Office Action Summary

10/591,069

DOPPSTADT ET AL.

DETAILED ACTION

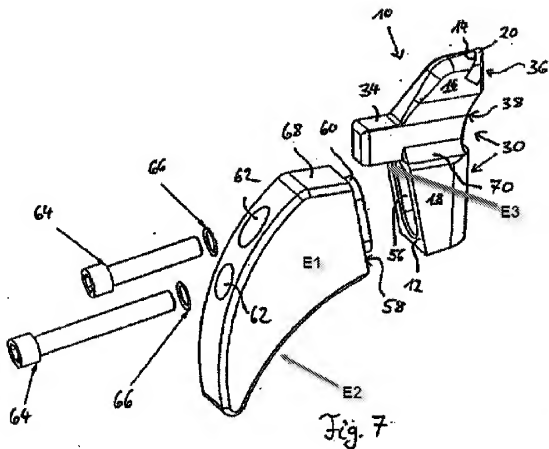
Concerning claim 31, *Pizzuto* discloses, in figure 7 below, a knife holder comprising a tooth body (E1) which is capable of being fastened on a cylinder due to it's shape and a knife body (10) which is able to be attached to the tooth body in a positive locking manner through the knife receiving device (60) which is a recess which is wedge shaped. *Pizzuto* does not disclose the receiving device having a J shape.

Concerning claim 35, *Pizzuto* discloses in figure 7 the tooth body (E1) and the knife (18) have shapes which correspond. The further limitations are alternative structural limitation and thus not necessary for rejection purposes.

Concerning claim 36, *Pizzuto* discloses in figure 7 the tooth body (E1) has on its bottom surface (E2) a centering device which is the curved part of the bottom surface which centers the holder on the commutation cylinder. The further limitations are alternative structural limitation and thus not necessary for rejection purposes.

Concerning claim 39, *Pizzuto* discloses in figure 7 the outer radius of the tooth body cuts on its side opposite the knife receiving device (60) which is also the outside radius of the comminuting cylinder. The further limitations are alternative structural limitation and thus not necessary for rejection purposes.
